Subject: AP1000 COL Response to Request for Additional Information (TR 29)

Westinghouse is submitting a revised response to the NRC request for additional information (RAI) on AP1000 Standard Combined License Technical Report (TR) 29, APP-GW-GLR-044, Nuclear Island Basemat and Foundation. This RAI response is submitted in support of the AP1000 Design Certification Amendment Application (Docket No. 52-006). The information included in the response is generic and is expected to apply to all COL applications referencing the AP1000 Design Certification and the AP1000 Design Certification Amendment Application.

RAI Response Number: RAI-TR29-SRSB-01
Revision: 1

Figure 2-1
Turbine Trip
(Peak Pressure Case)

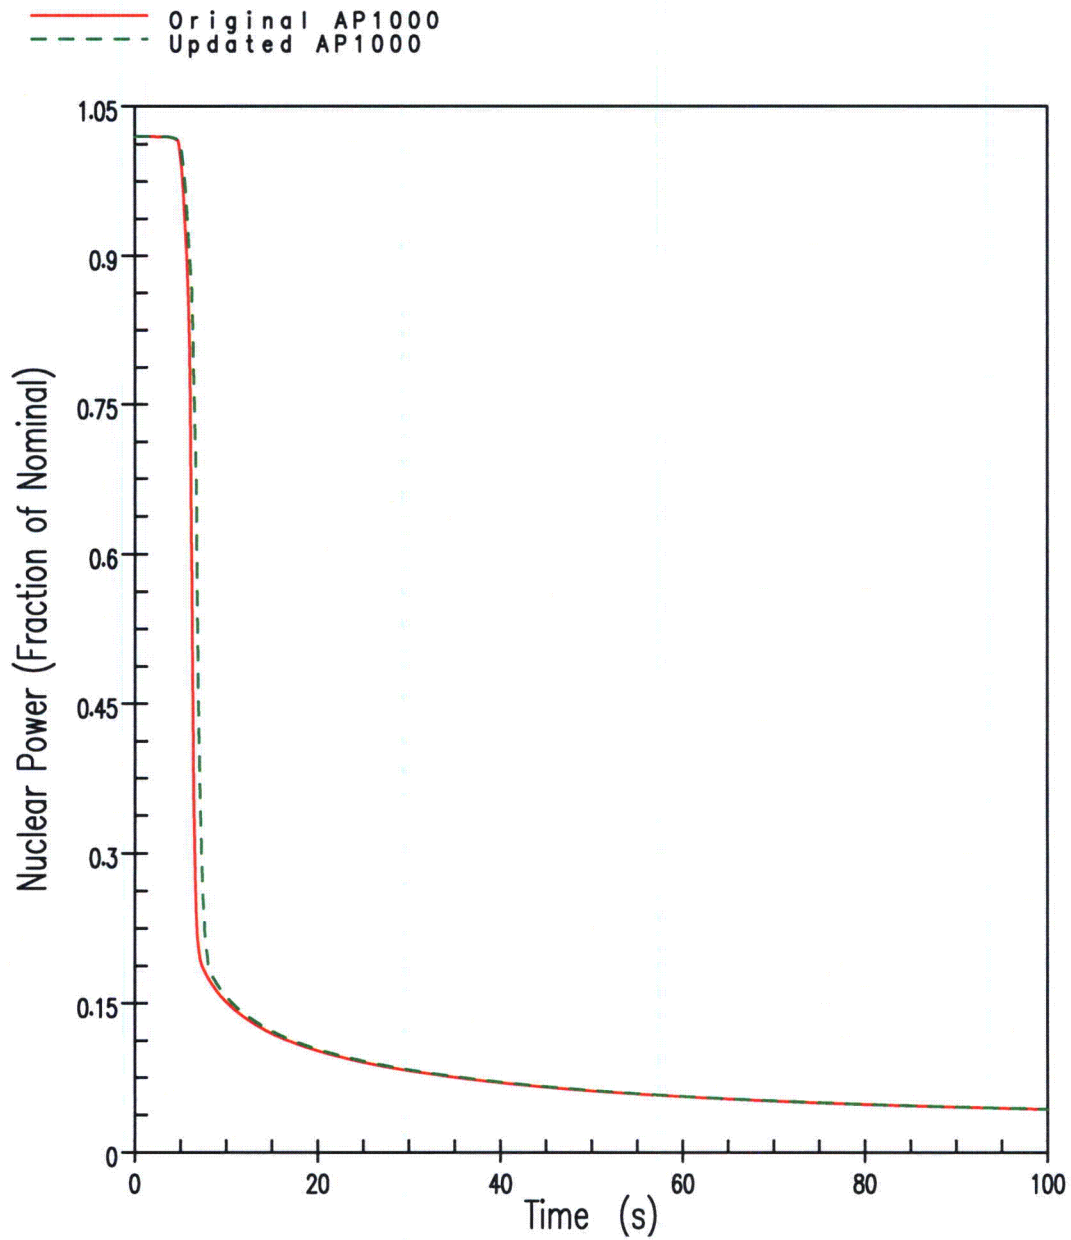
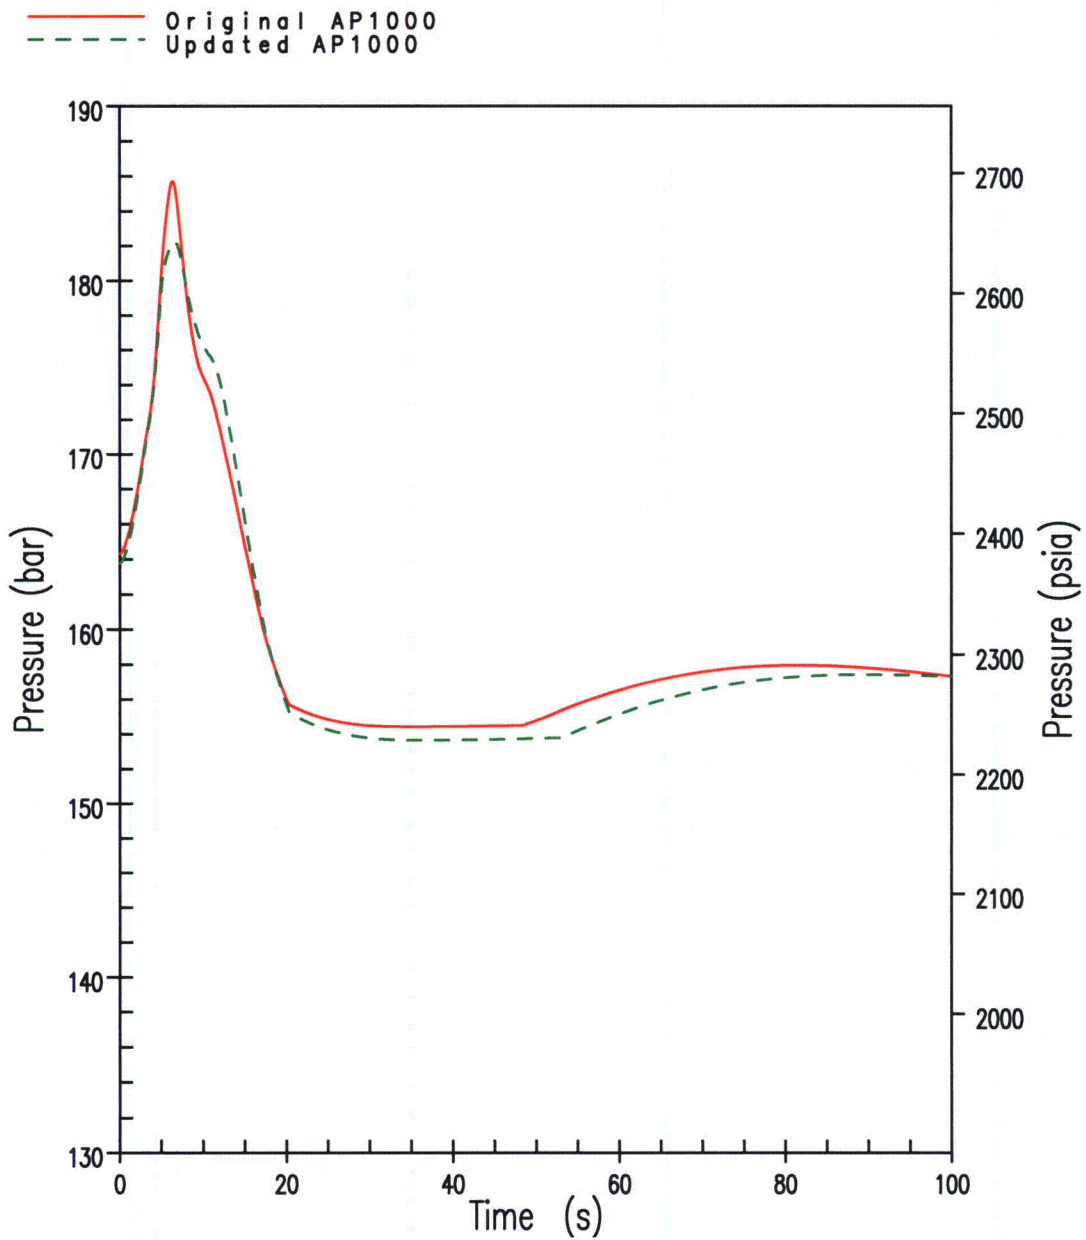
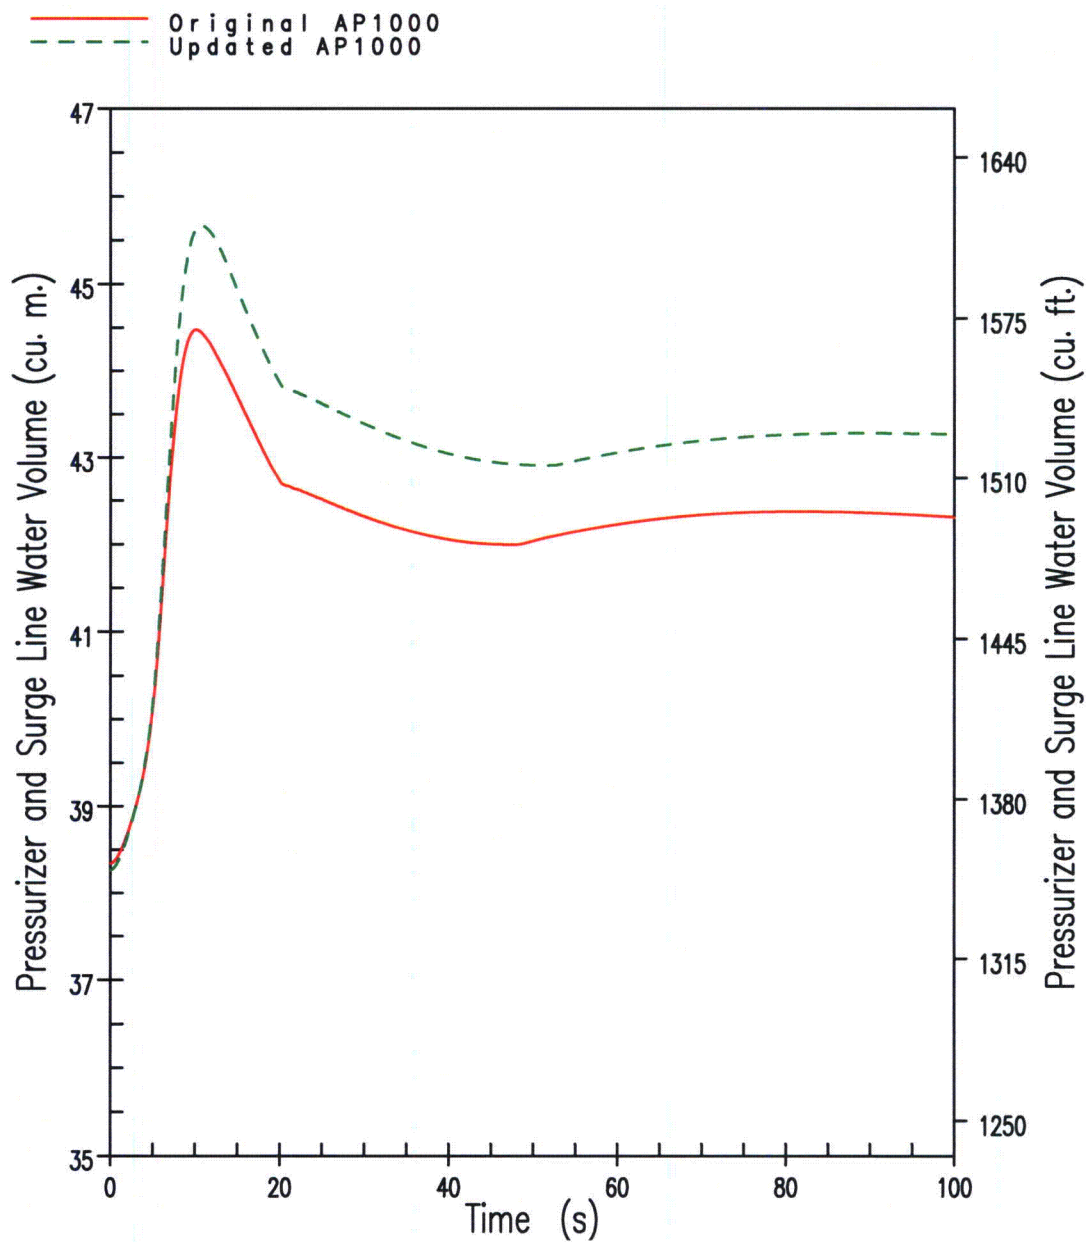
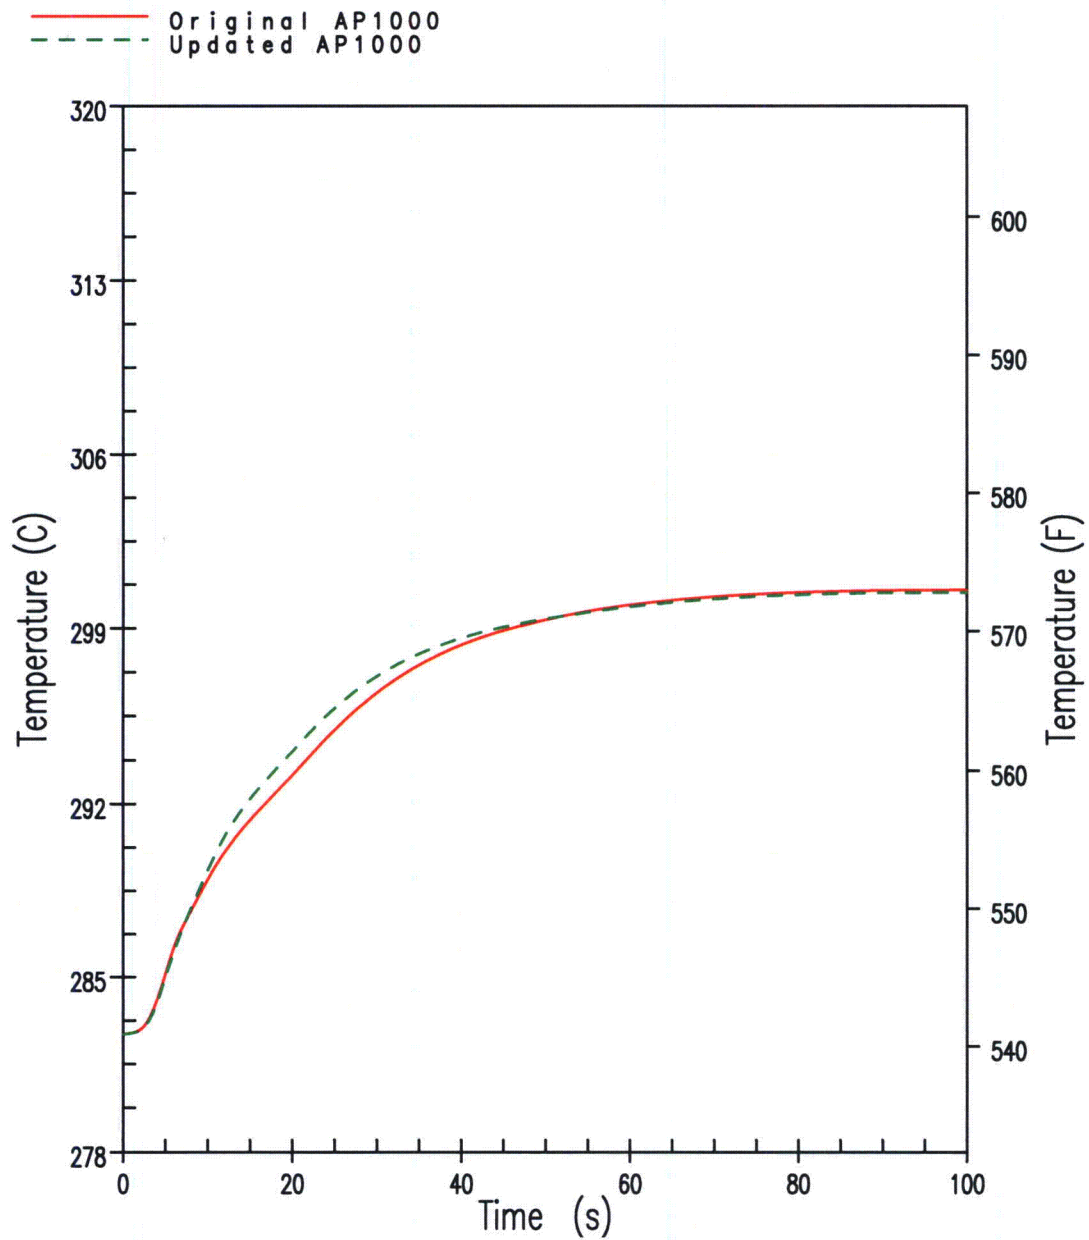
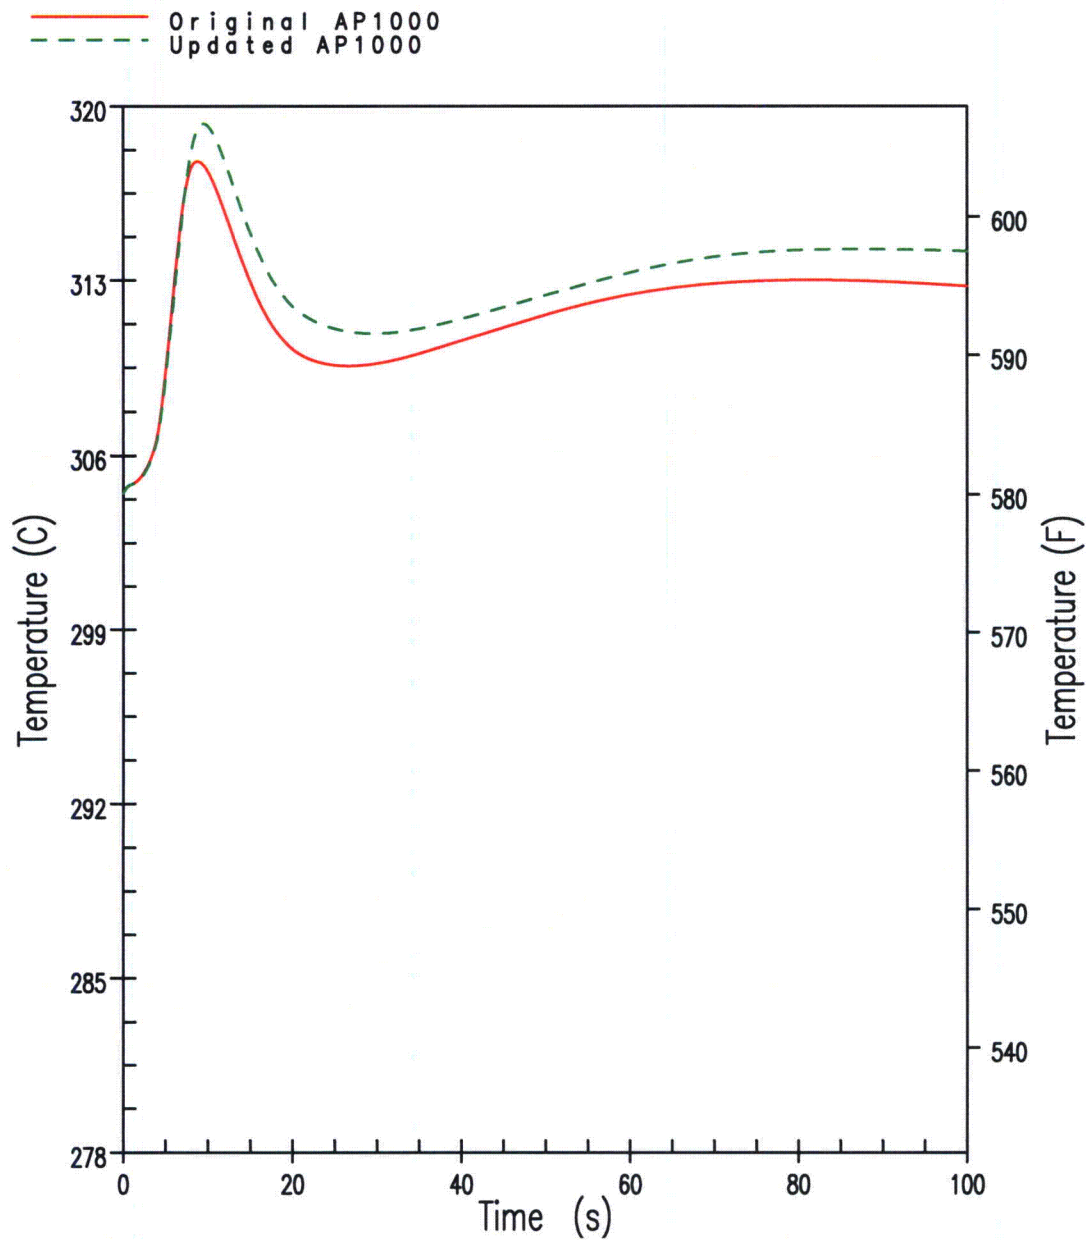
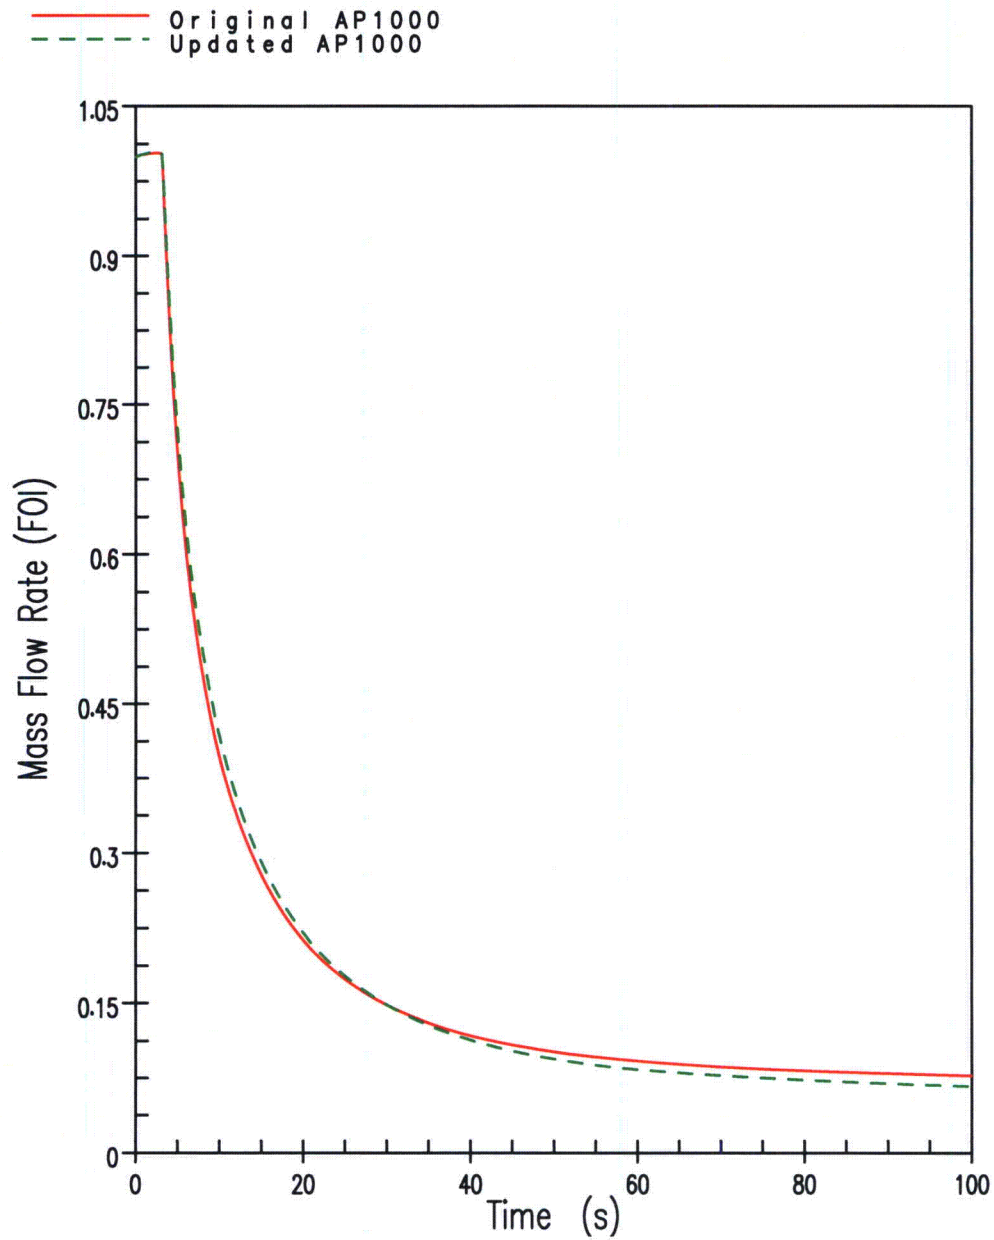
Please provide an evaluation of the impacts of these proposed changes on the analysis results of each of the transients and accidents in DCD Chapter 15. The evaluation should demonstrate either the analysis results of DCD Chapter 15, Revision 15, remain bounding and valid, or the effects of these changes are insignificantly small that the applicable acceptance criteria for these transients and accidents remain complied with.

The most limiting case with respect to maximizing reactor coolant pressure occurs without the pressurizer pressure control system available, with minimum reactivity feedback, and without offsite power available. Results for this case are shown in Figures 2-1 through 2-6. A sequence of events for this case is provided in Table 2-1 and is identified as Case C.2. The maximum reactor coolant pressure for the updated AP1000 configuration is 2642.77 psia [182.2 bar] as compared to 2693.65 psia [185.7 bar] in the original AP1000 plant configuration. The overpressurization results are less severe for the updated AP1000 plant.
